51TGS/HARNESS

Upgrade tilt switch service kit for the following kits:

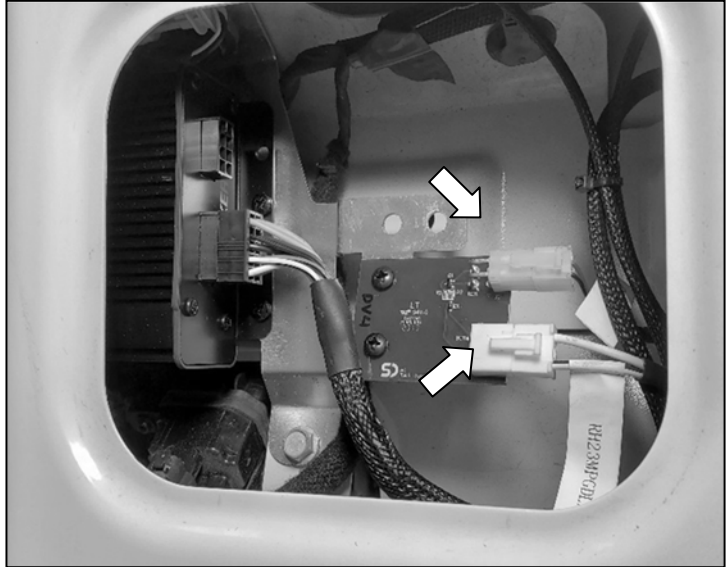
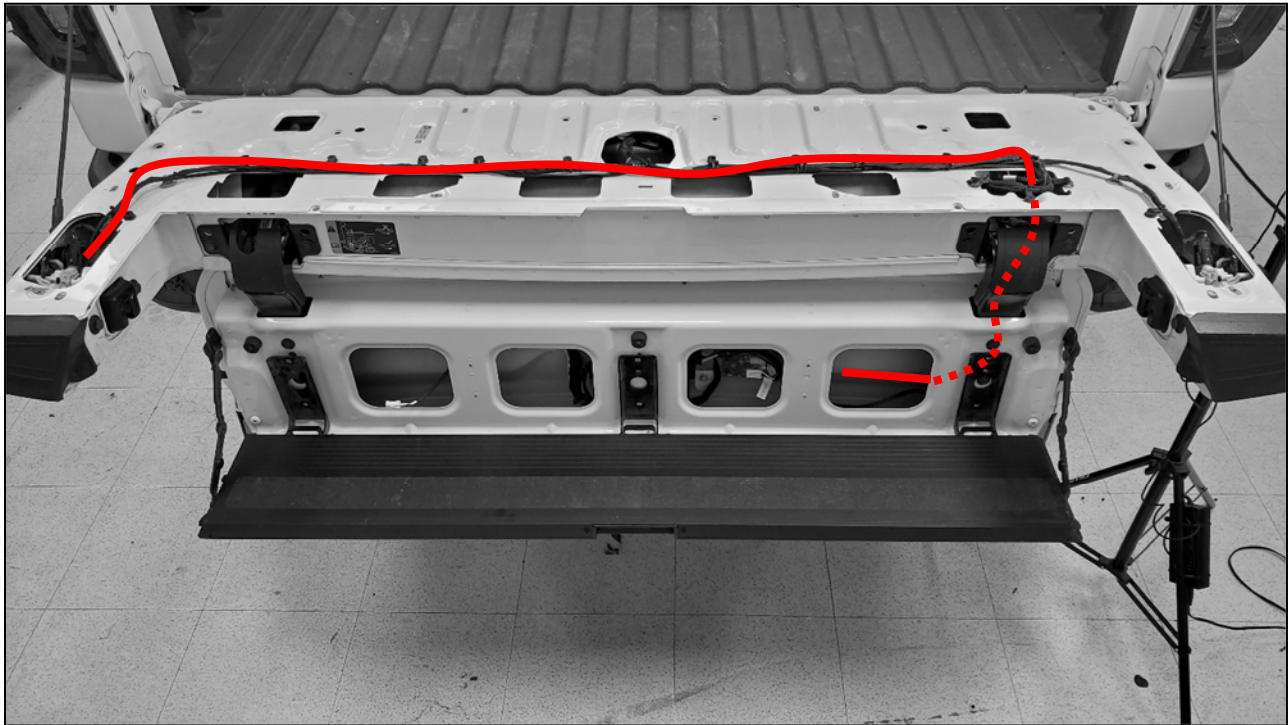
3. Remove the two screws securing the tilt switch to the amplifier bracket.

4. Replace the tilt switch with the solid-state circuit board provided using the supplied screws. Reconnect the three-pin connector and connect the two-pin connector of the supplied latch T-harness.
